NONCONFORMANCE REPORT

16 NCR NO. C-01006

Watertight doors & frames

Contract A17AQ Julius Mock & Sons, Inc.
 Watertight doors & frames

Door # 205

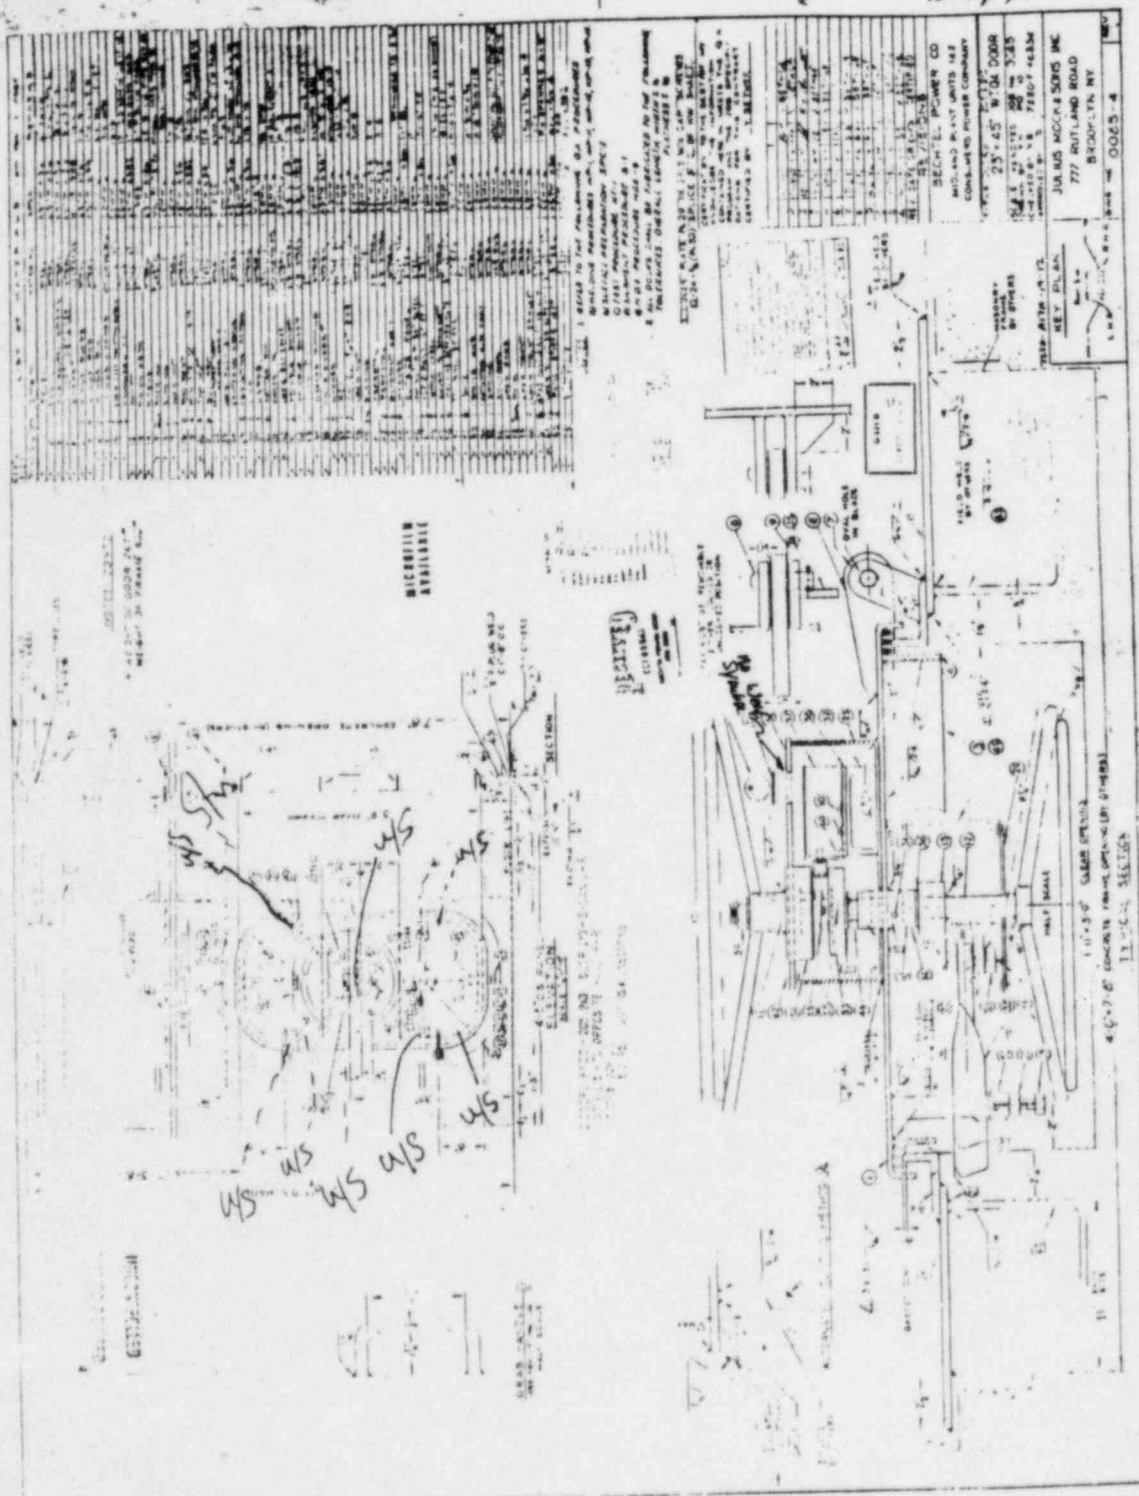
u/c = undercut
 u/s = underwrite
 m/s = are markings
 L.F. = Lack of Finish

Door # 53

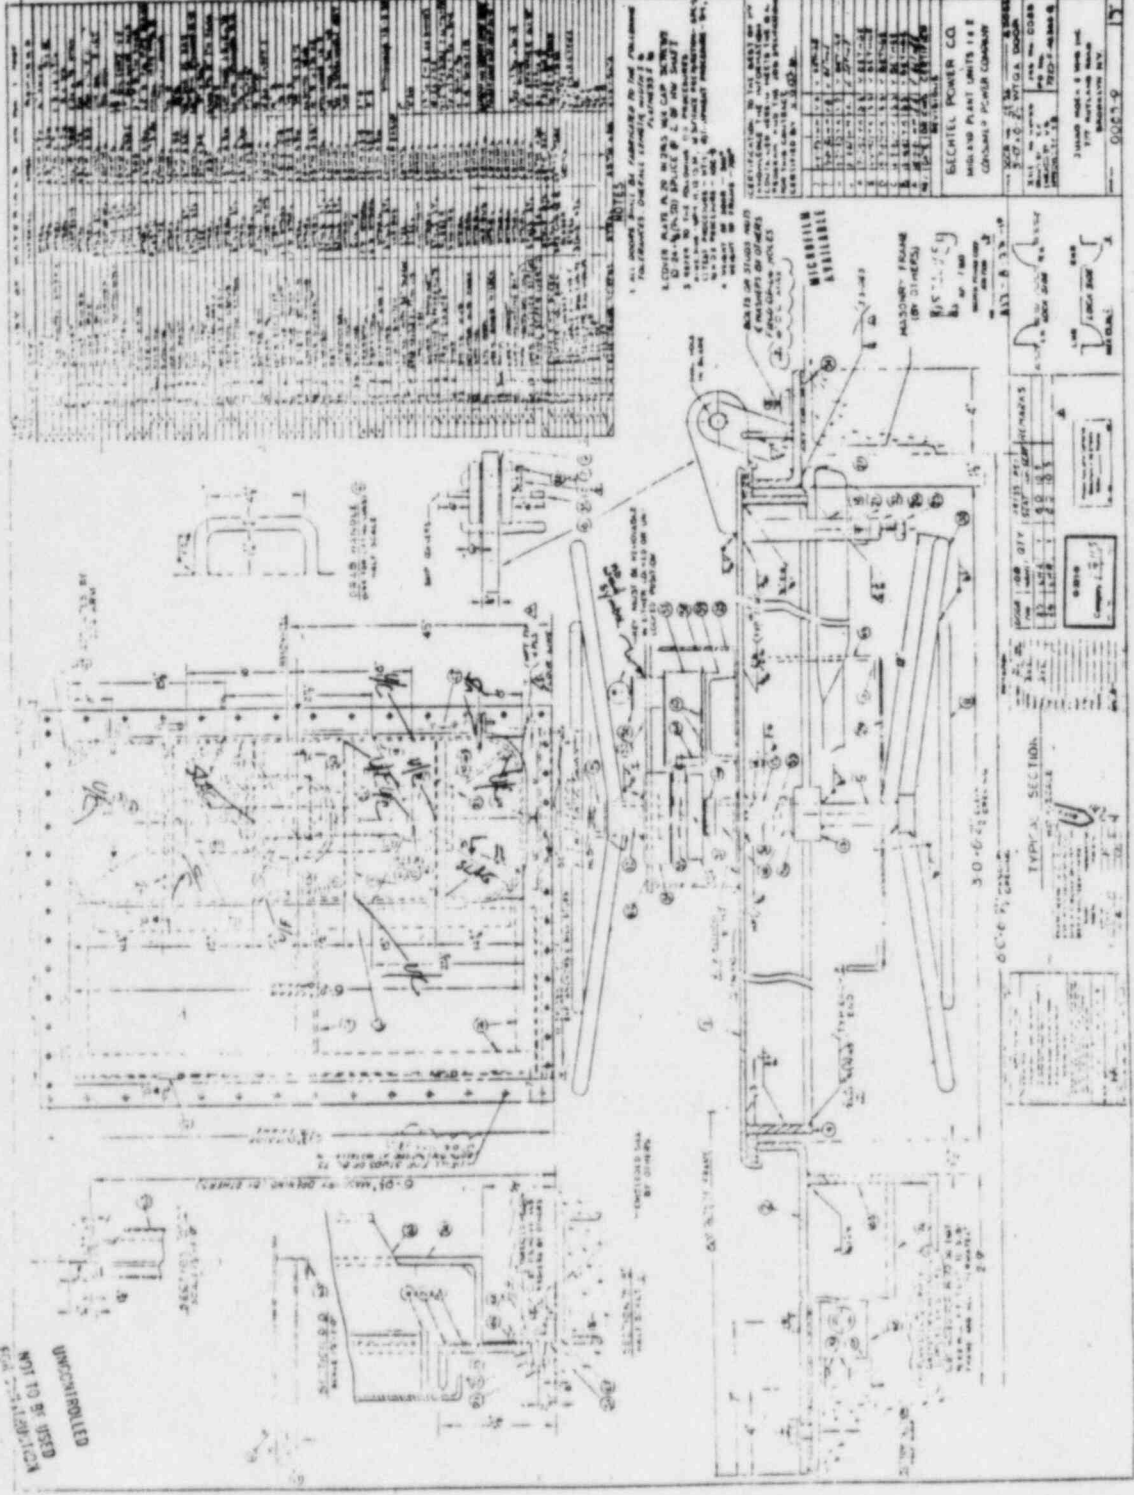
C.L. = Cold Lap
 P.D. = Porosity
 L.F. = Leak of Fuel
 U.C. = Undercut
 U.S. = Under Size
 U.F. = Under Fill

Door # 24
 (C)

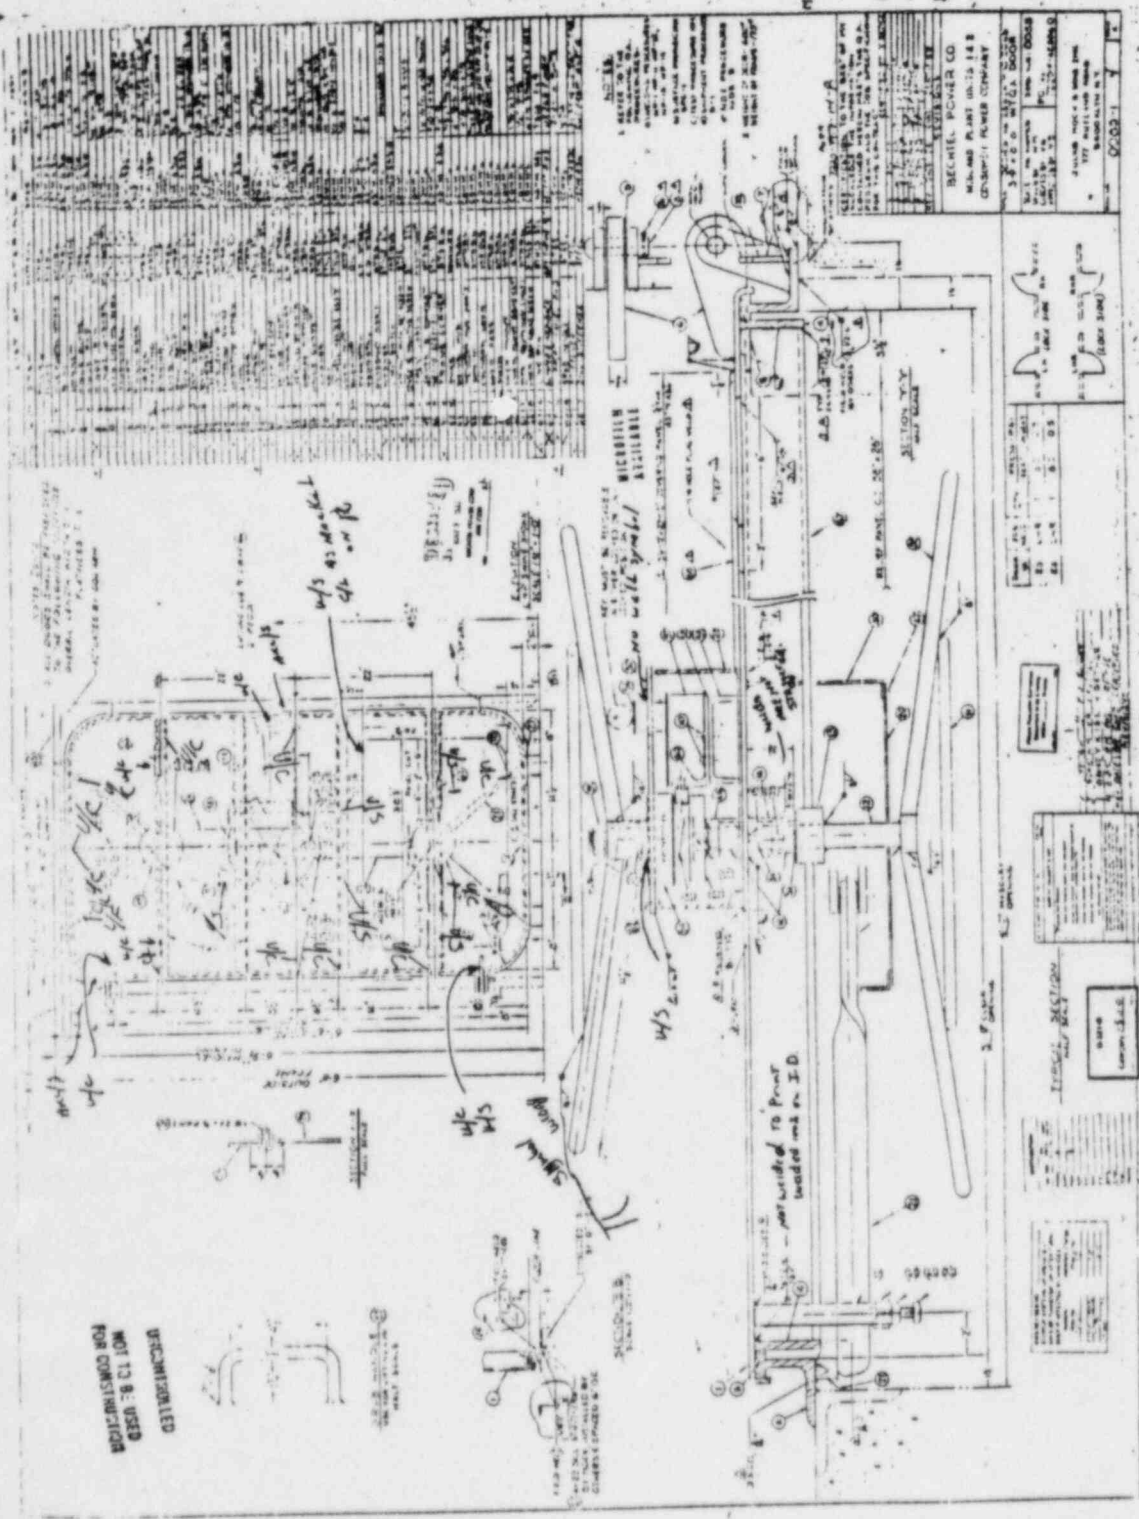
- w/c
- w/s
- c/l
- m/s
- w/f

Inside of door mounted
up with de Greys.

Door #77 ©

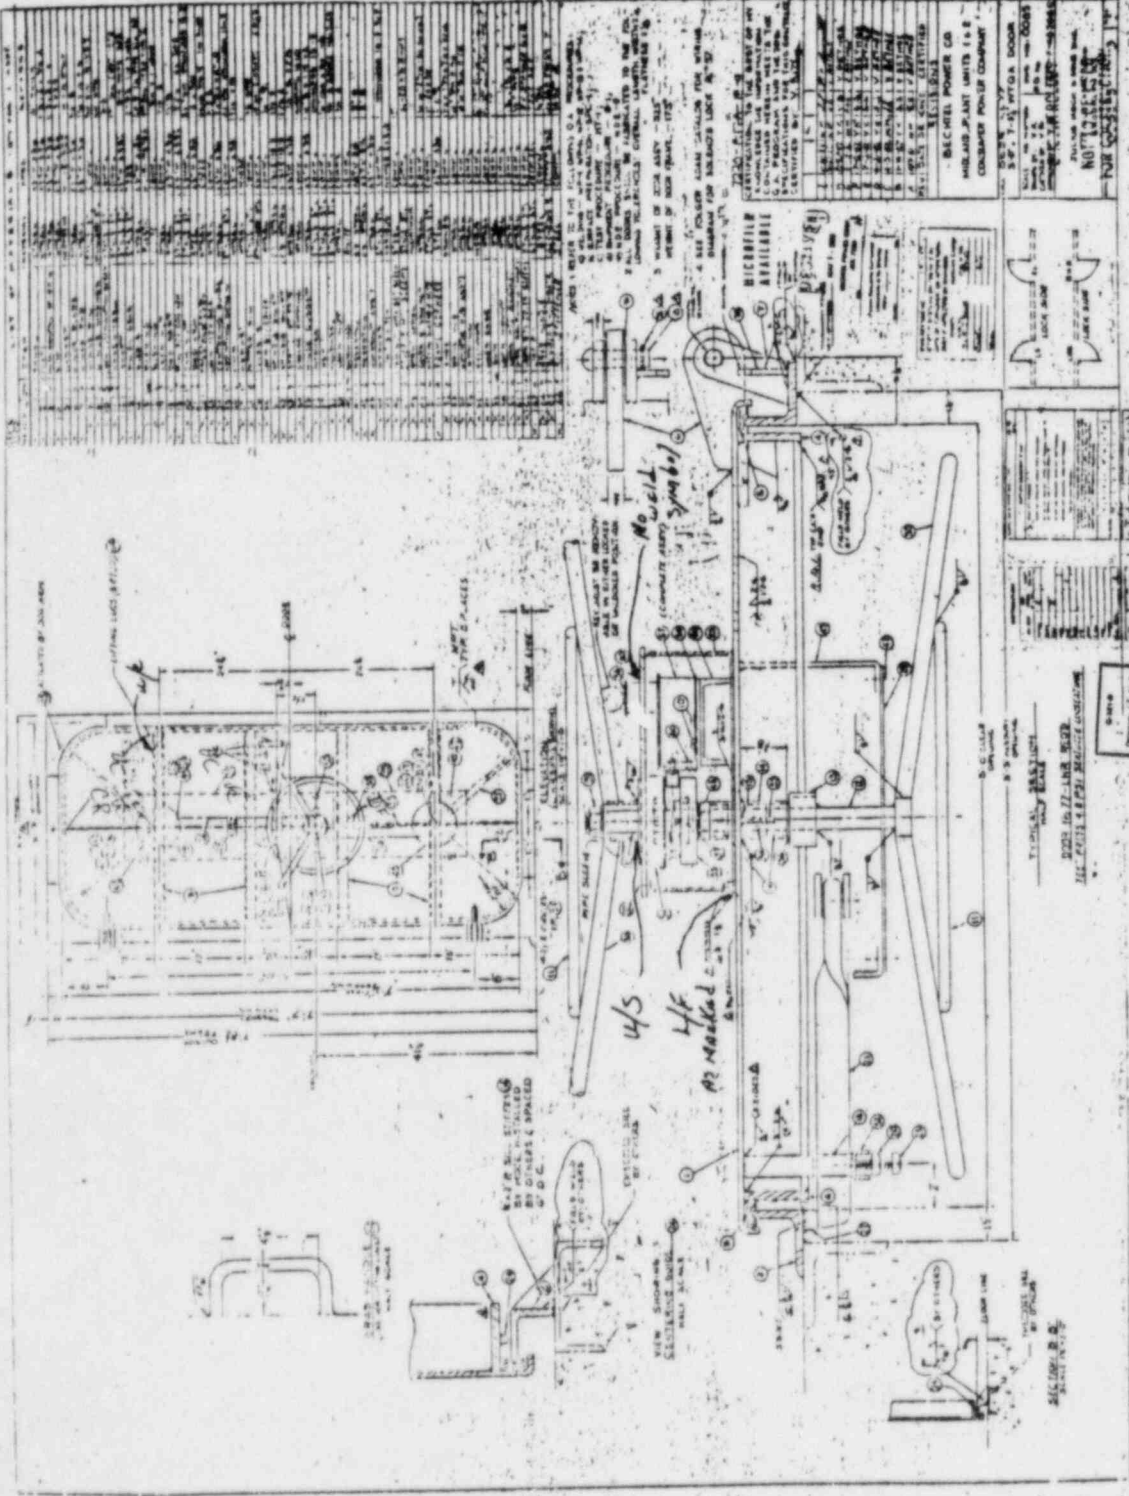
C.R. = cold roll
 L/F = lack of fusion
 u/c = undercut
 u/s = under size

Door #31 @

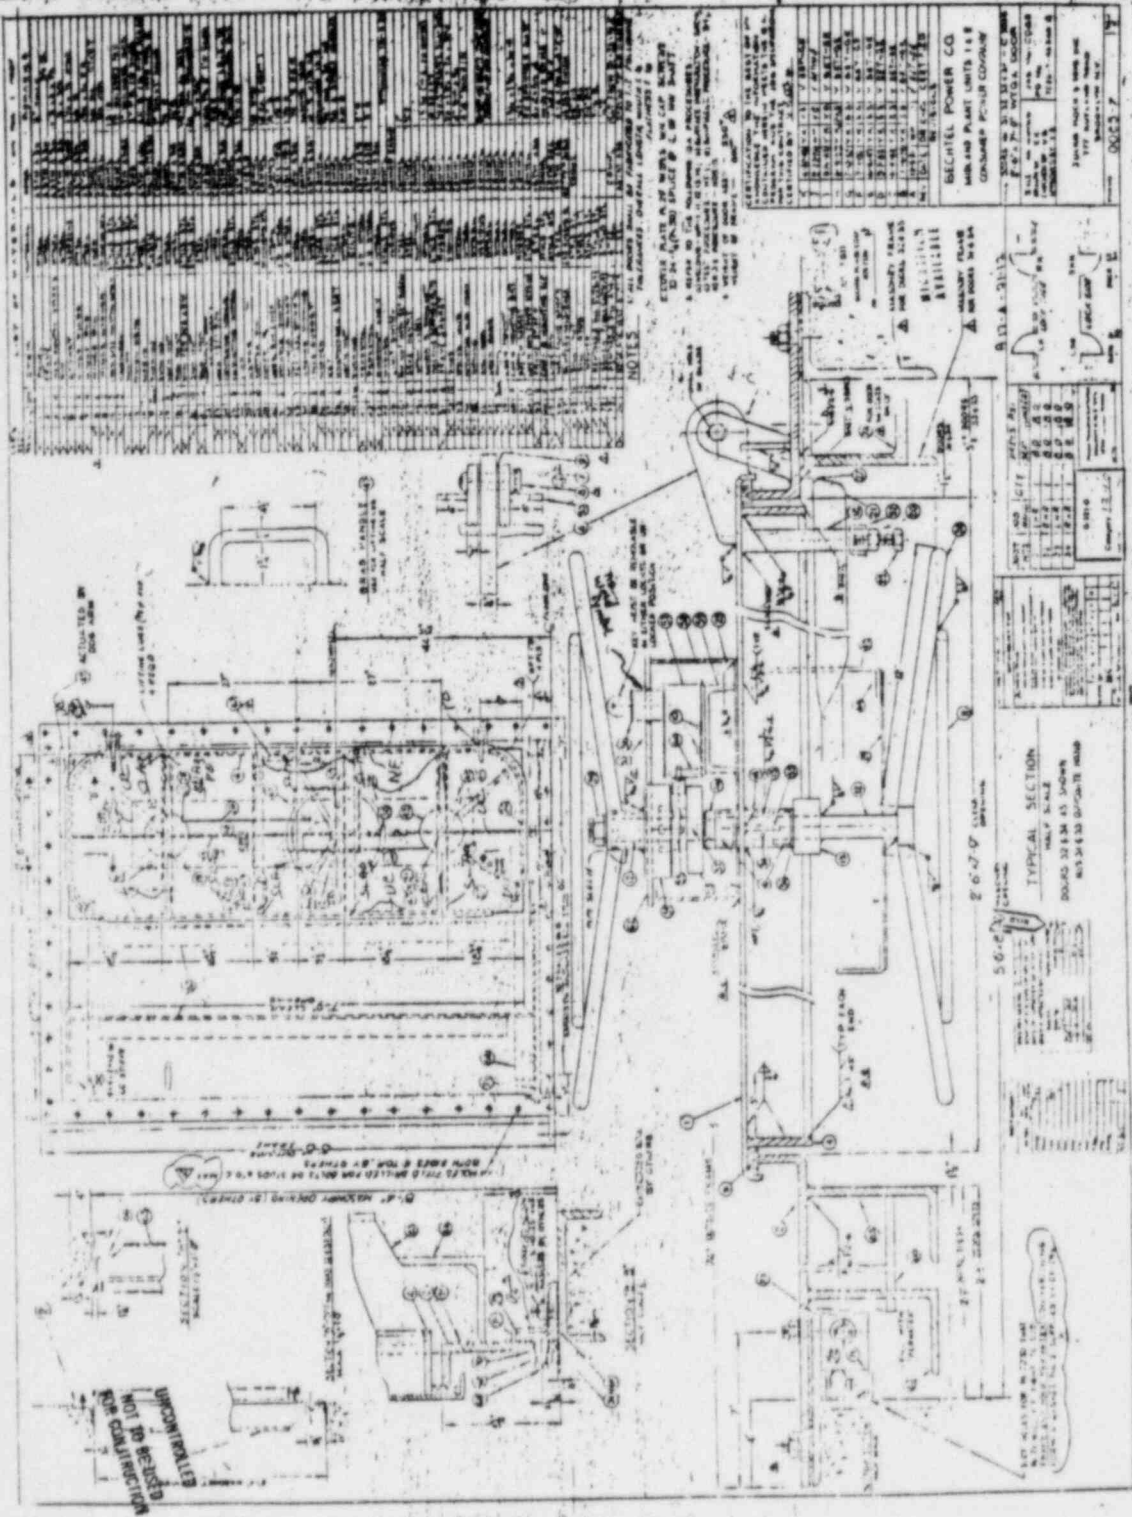
4/C = UNDERCUT
 PO = POROSITY
 4/S = UNDER-SIZE
